ORIGINATION FORM

Proposed Revisions to a Standard Plans Index (Please provide all information — Incomplete forms will be returned)

Index Number: 515-062

Index Title: Bicycle Pedestrian Railing (Aluminum)

TYPICAL SECTION ON CONCRETE SIDEWALK (Case I)

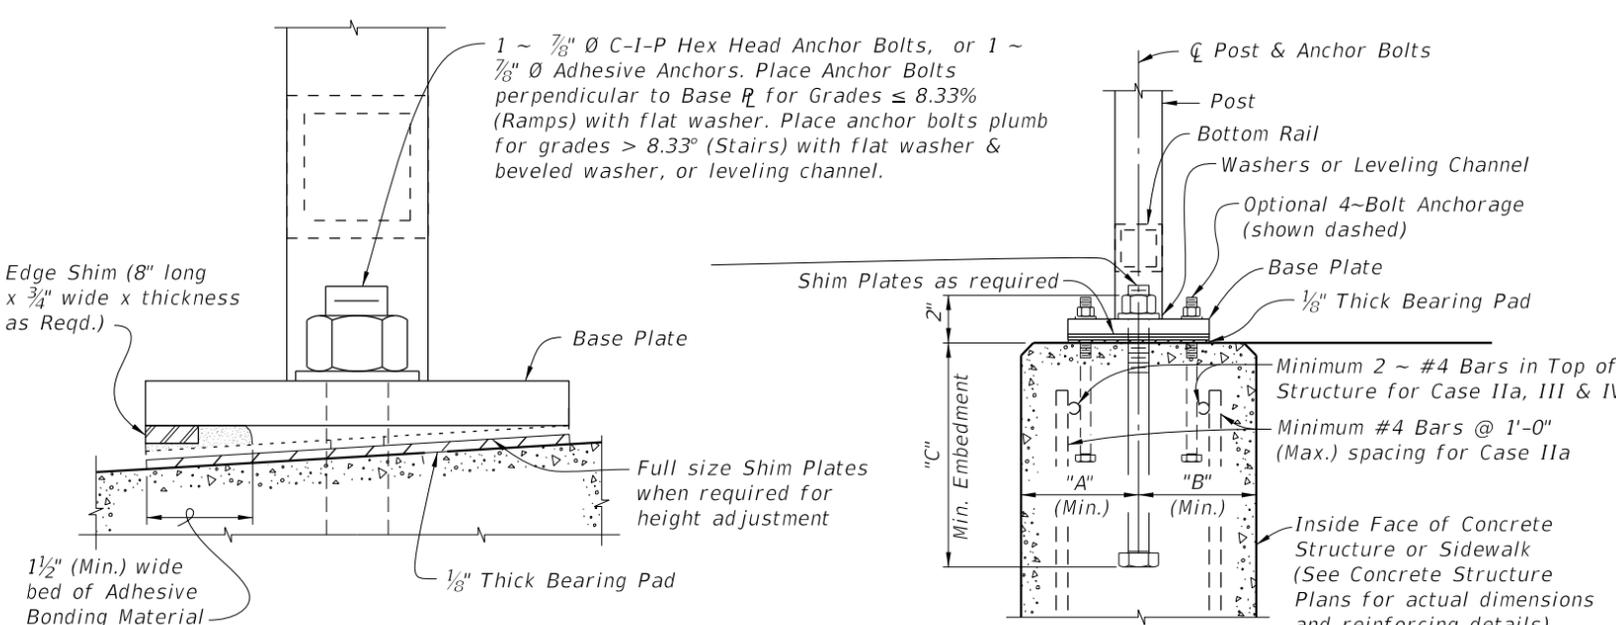
Change edge beam of sidewalk to 9" deep.

Due to research, embedment was reduced to 6"; therefore, the depth can be reduced to 9".
